Re: Response to Request for Additional Information (RAI)
Project No. 0010001-011-AC
Florida Power Corporation d/b/a Progress Energy Florida, Inc.
University of Florida Cogeneration Plant
Alachua County

Response to RAI - UF Cogen

Project No. 0010001-011-AC

Deltak HRSG Venting and Coen Duct Burner Evaluation

HP Steam Flow vs Burner Output

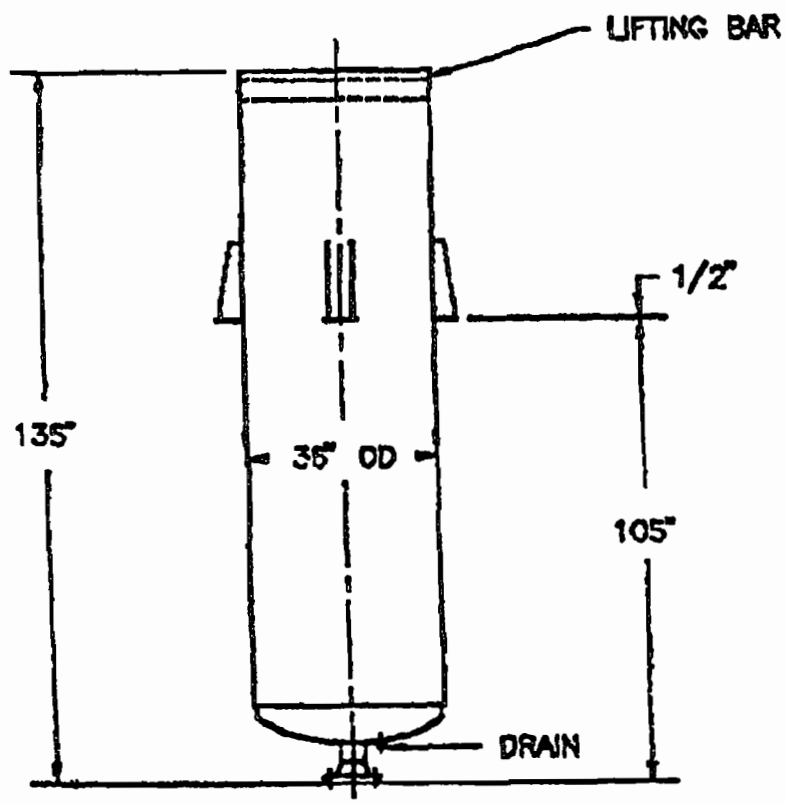
Looking back over the past years worth of operating data the maximum firing rate of the duct burner was 93,500 scfh. A chart of high pressure steam flow vs. burner fuel flow is attached. In general operations will fire the HRSG up to a maximum of 160,000 lbs/hr of high pressure steam flow at approximately 75,000 scfh. If additional flow is required one of the backup steam generators is used.

TITLE:
SILENCER (START-UP VENT)

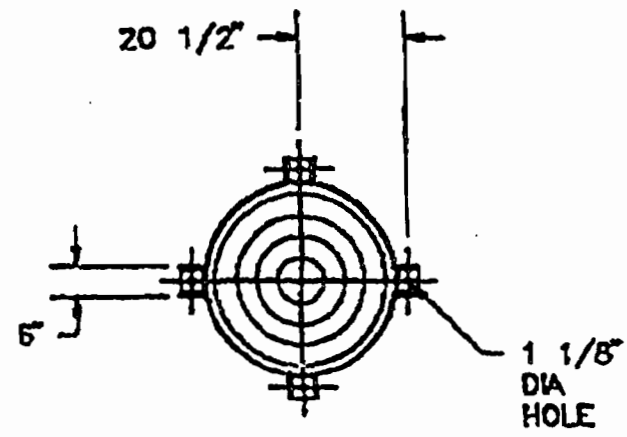
The capacity of the Fluid Kinetics high pressure vent silencer is 60,300 lb/hr per drawing 9670131 (attached). The Coen duct burner capacity is 244,565 standard cubic feet per hour according to the Coen technical manual (excerpt attached).
